CHARLTON
RIVERSIDE
P H A S E O N E

LANDSCAPE AND BIODIVERSITY DAS ADDENDUM

Design & Access Statement Addendum

Date	November 2018
Revision	A
Written	ExA
Checked	KI -Senior LA
Approved	SM -Director
Doc Ref:	ExA_DAS Addendum

PLOT A RELOCATE CAR PARK ENTRANCE

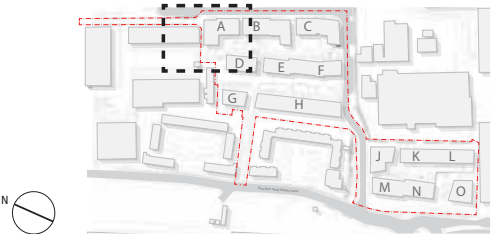
The layout of Building A was amended to include a basement carpark entrance. This has resulted in changes to the landscape as follows:

- 1 New planters to the basement carpark entrance
- 2 The road on the eastern boundary has been widened to accommodate two-way traffic into the basement carpark in building A.
- 3 A new planter replaces the private amenity terrace on the north western corner of the building. The building slab has been raised locally to accomodate the length of the carpark ramp below.

ACTIVATE STREET FRONTAGE ALONG THE FUTURE EAST WEST LINK

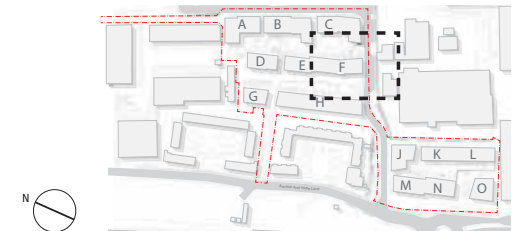
The car park entrance has been relocated from Building F and replaced with apartments to encourage activation along the east-west link.

- 1 The carpark entrance to Building F has been replaced with 3x apartments. Entrances for two of these is directly off the footpath of the east west route to encourage activation of the street frontage. The finished floor levels of the apartments are 'stepped' to work with the road levels.

- 2 3x private amenity spaces have been added to the proposed additional 3x apartments.
- 3 The east west route has been slightly realigned following the removal of the basement carpark entrance

- Levels have been reviewed and revised along this road and now represent a more gradual incline over a longer distance. Refer to drawings ExA_1752_301 & 302

- 4 A vehicle restraint barrier has been added to the southern red line boundary adjacent to the east west route to respond to the level change between existing and proposed levels.

- 5 The seating area in front of the Community Centre space has been set back further from the road to accommodate road realignment and revised levels.

PLOT B SET BACK CORNER OF BUILDING M

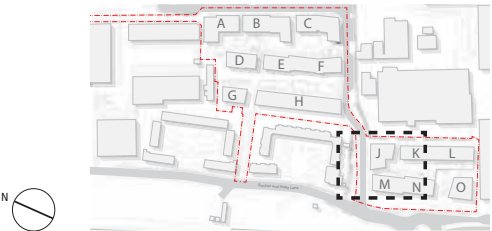
Building M has been set back and curved on the northern side to allow for the roundabout and associated cycle path on the future road plan.
This has resulted in minor changes to the landscape as follows:

- 1 Amendments to the planting on the northern edge of Building M at ground floor
- 2 Adjustments to 2x of the private amenity spaces at podium level
